AMENDMENTS TO THE DRAWINGS

Please enter the four (4) replacement sheets for drawings sheets 1/13, 7/13, 8/13 and 9/13, which include Amendments to Figs 1, 10, 11 and 12, respectively. The changes effected therein are shown by the red-line markings in the accompanying annotated sheets corresponding thereto. The replacement sheets are enclosed herewith as Appendix A and the annotated sheets are enclosed here with as Appendix B. The amendments to the drawings include the following:

FIG. 1

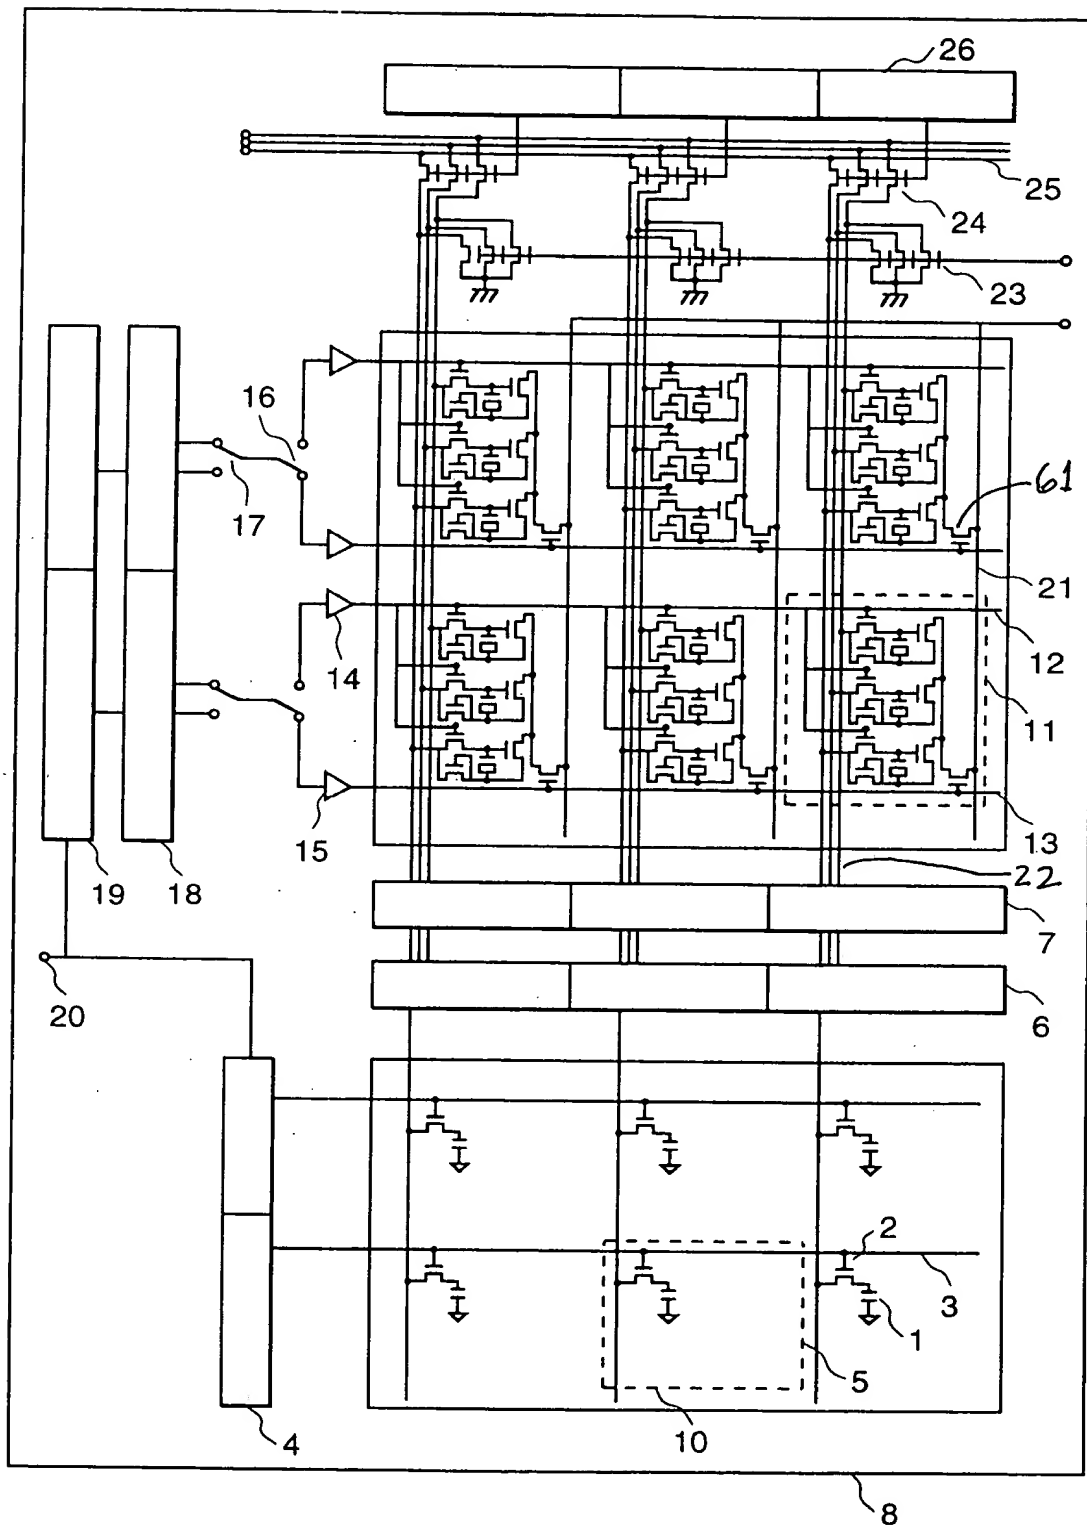
In Fig. 1, the referred to read-out switch 61 in paragraphs [0045], [0050], etc., in the Substitute Specification, is now labeled therein; also in Fig. 1, the described data lines 22, referred to on page 8, paragraph [0032], is now labeled in Fig. 1 (this is also consistent with Fig. 7 of the drawings and the related description thereto).

~~62~~ 63

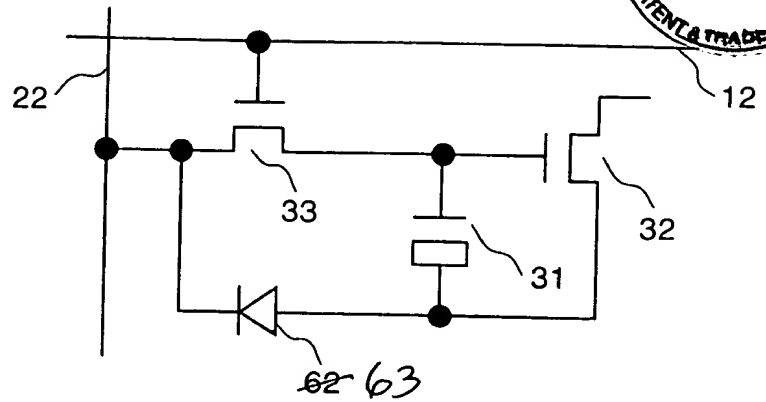
In Fig. 10, diode 62 was re-labeled as 63. (This change was effected to avoid conflict with the numerical character 62 which represents the memory cell in Fig. 9.)

FIG. 11

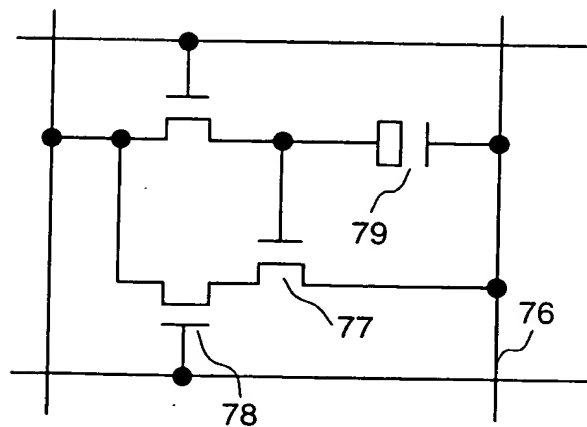
In Fig. 11, numerals 63 and 64 were replaced with numerals 64 and 65, respectively. (These changes were made in view of the change effected in Fig. 10.)

FIG. 12

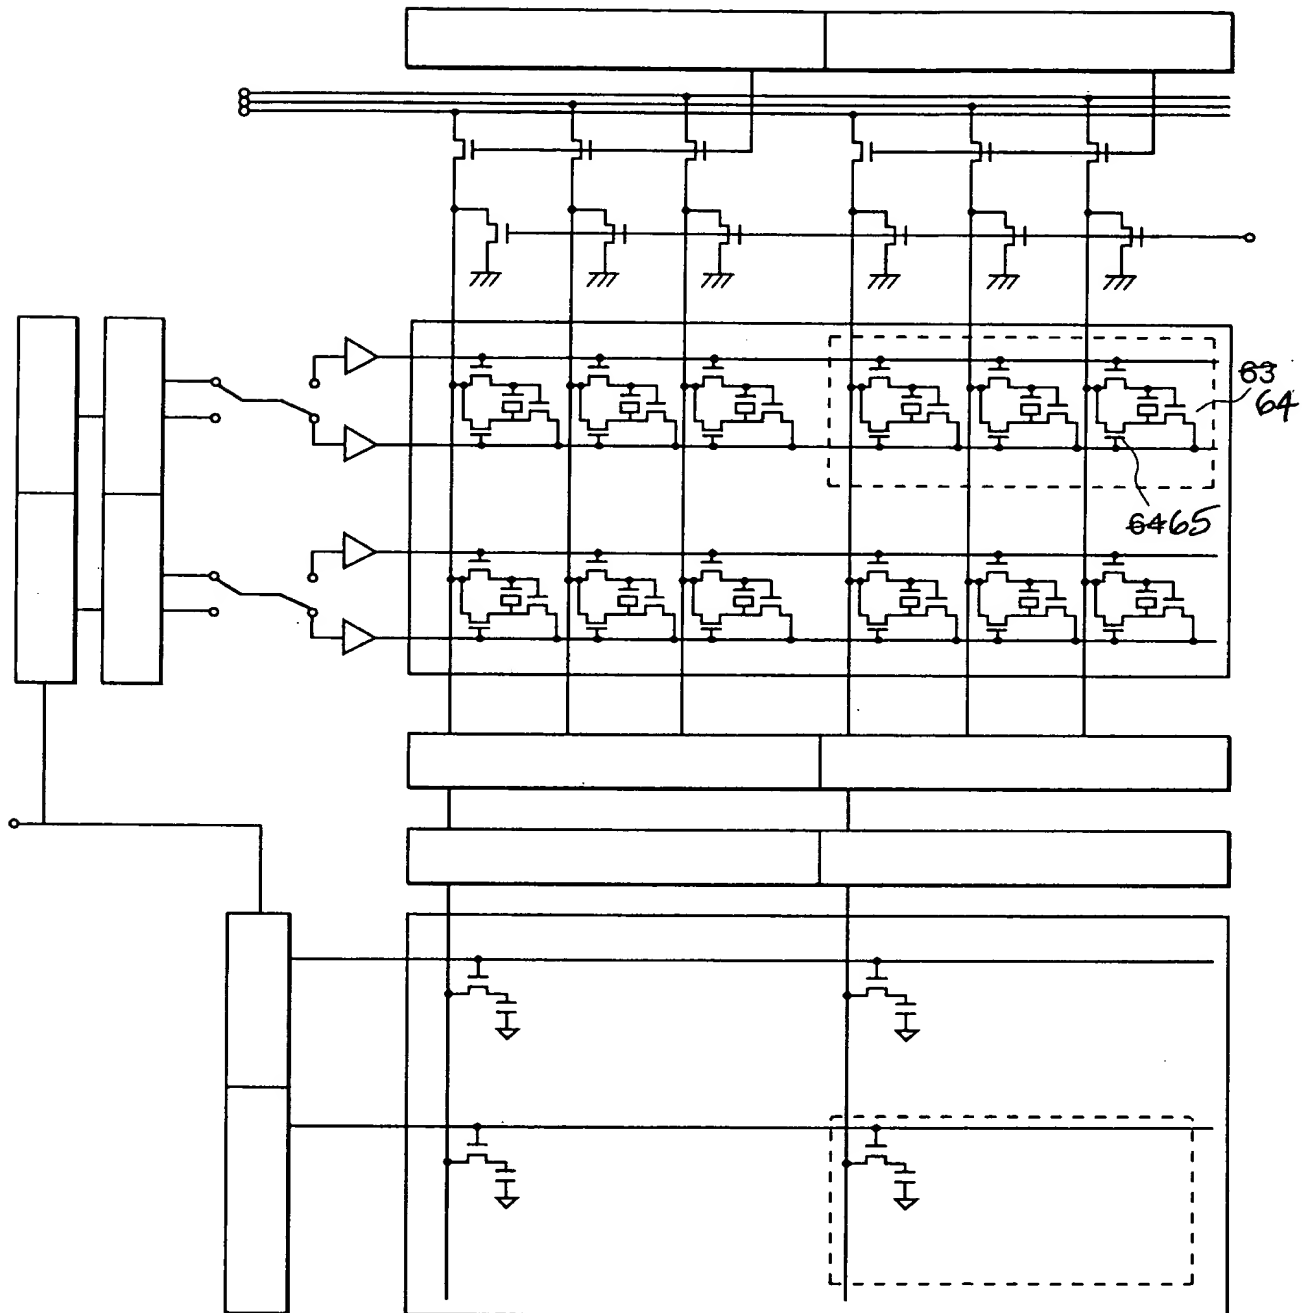
In Fig. 12, the numerical character 67 was added in connection with the latch circuit of the same number described on page 26, paragraph [0067], of the Substitute Specification.
